SERVICE CAMPAIGN BULLETIN

CAMPAIGN REF : 018
TITLE : Electric seat rework
DOCUMENT # : 11 N 002
AFFECTED VEHICLES : 12C Coupe

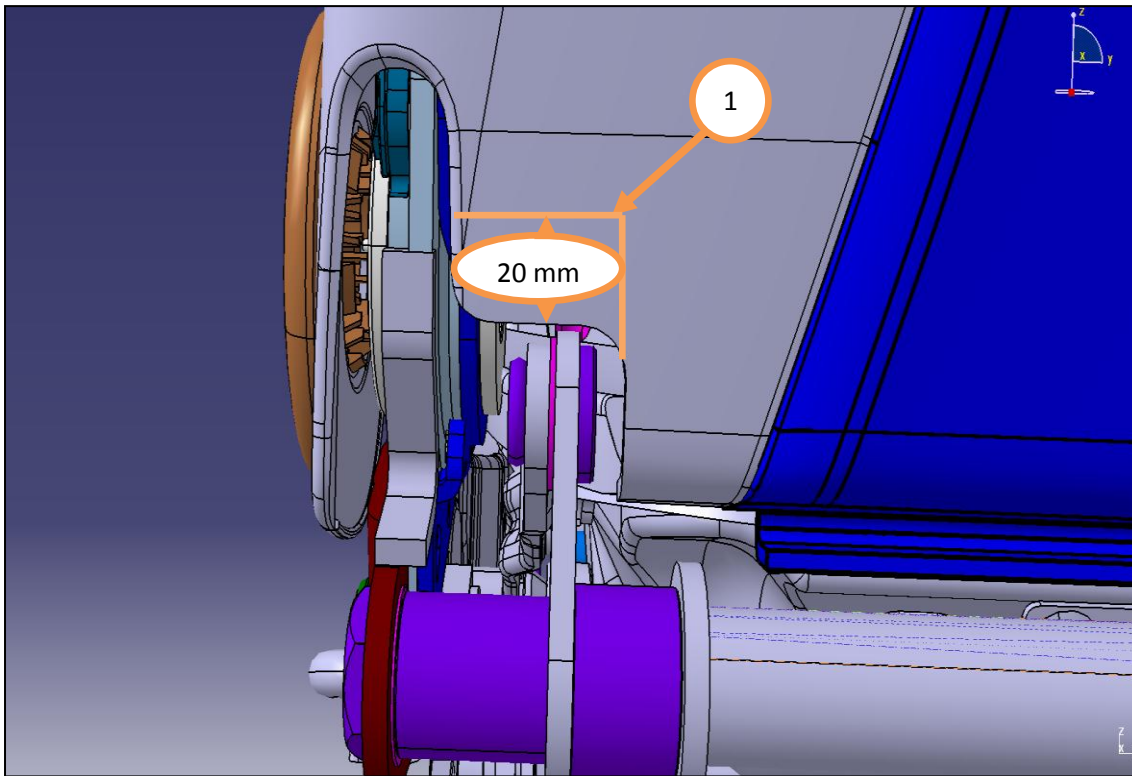
4. Mark out seat back area as shown below:

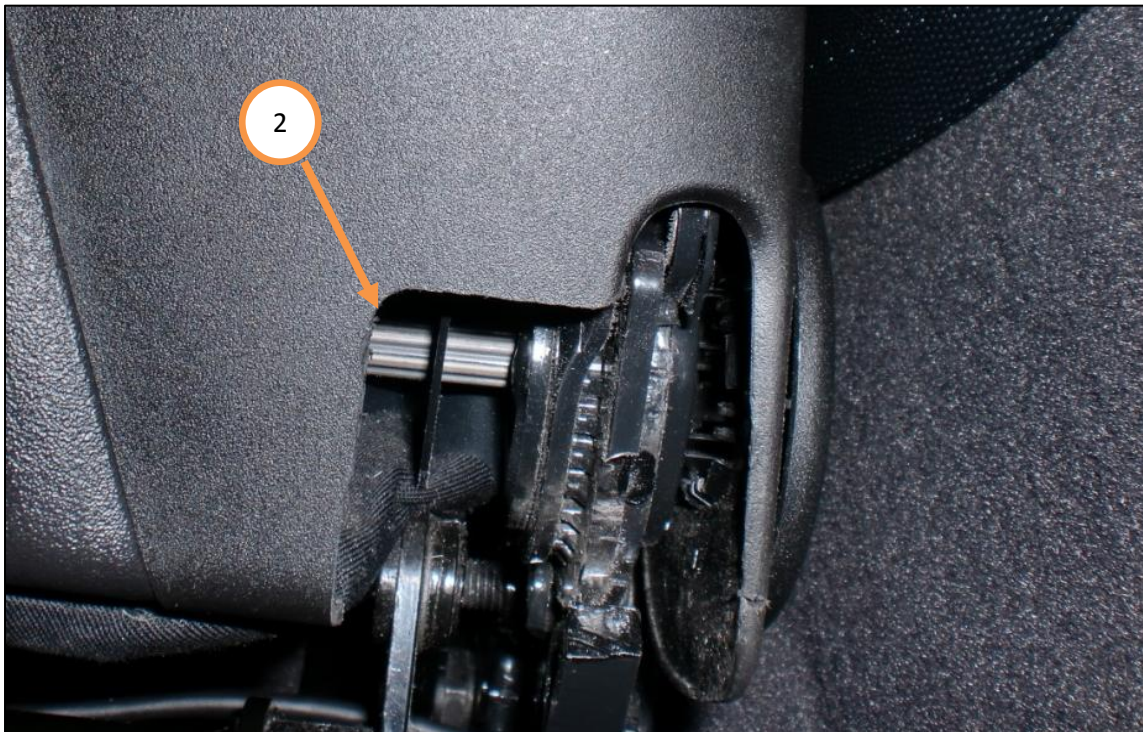
5. Cut away 20 mm of seat back plastic (1).

6. Ensure the sharp corners are rounded off, leaving no sharp edges (2).

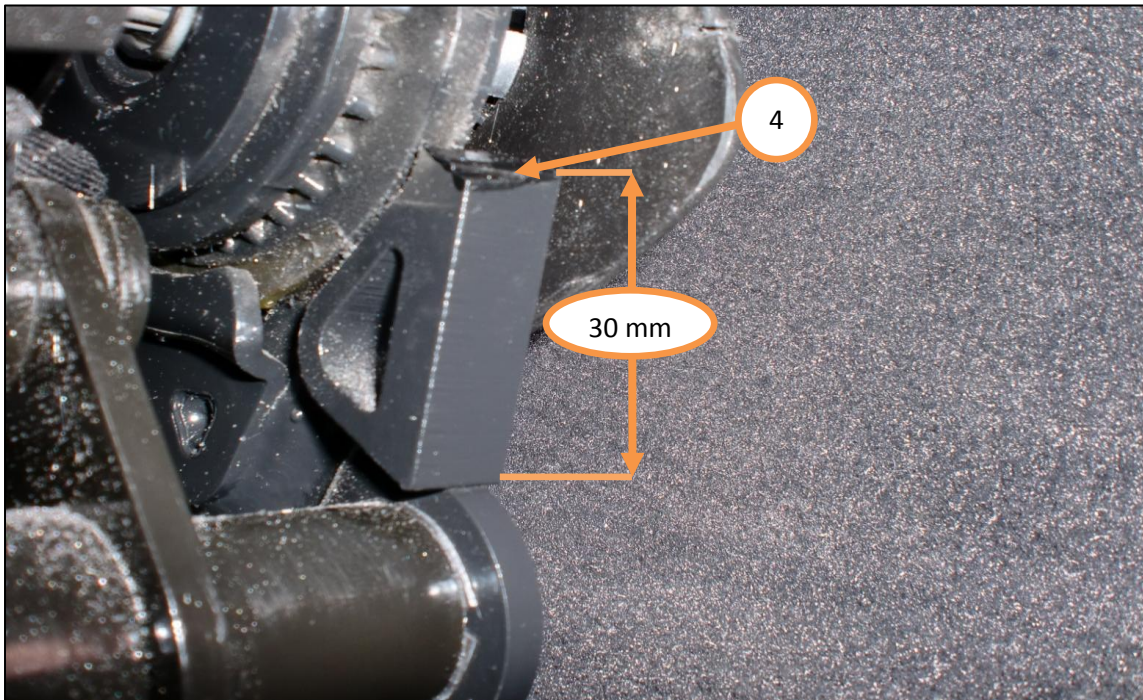
Care point: McLaren Automotive Recommend the use of a Dremel tool (3) to cut away the top section of the lower back stop.

7. Cut away the top section of the lower back stop leaving 30 mm remaining (4).

8. Clean away metal and plastic filings from the mechanism and paint the exposed metal (5).

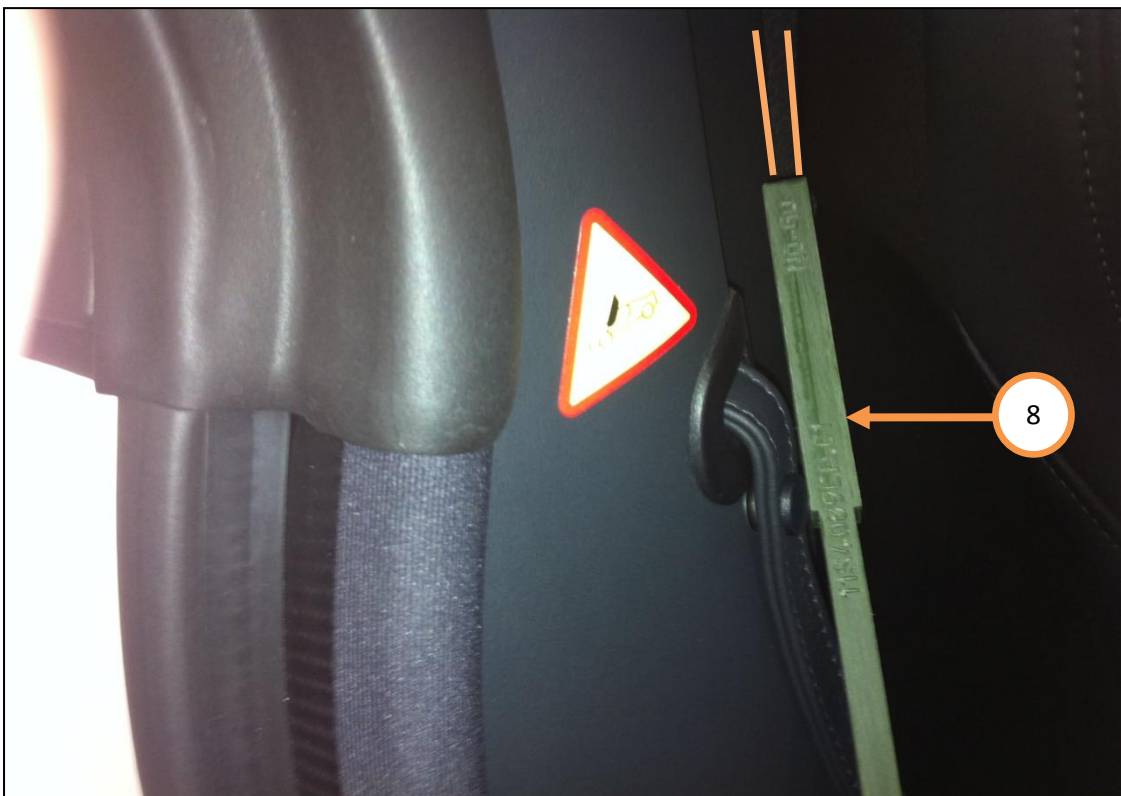
Care point: A seat calibration gauge (6) will be free issued in order to perform the below seat calibration process on affected vehicles.

Care point: The seat calibration gauge **needs** to be placed in the smallest gap between the seatback and B-Pillar trim in order for the calibration to be performed correctly.

17. Adjust the backrest angle until the desired gap between seatback and B-Pillar has been achieved using the seat calibration gauge. The gap **must not** be narrower than the end of the calibration tool (7). The tool should move freely between the seatback and the B-Pillar

18. The gap **must not** be wider than the wide end of the seat gauge (8). If the seat is in the correct position the tool should not be able to fit between the seatback and B-Pillar.
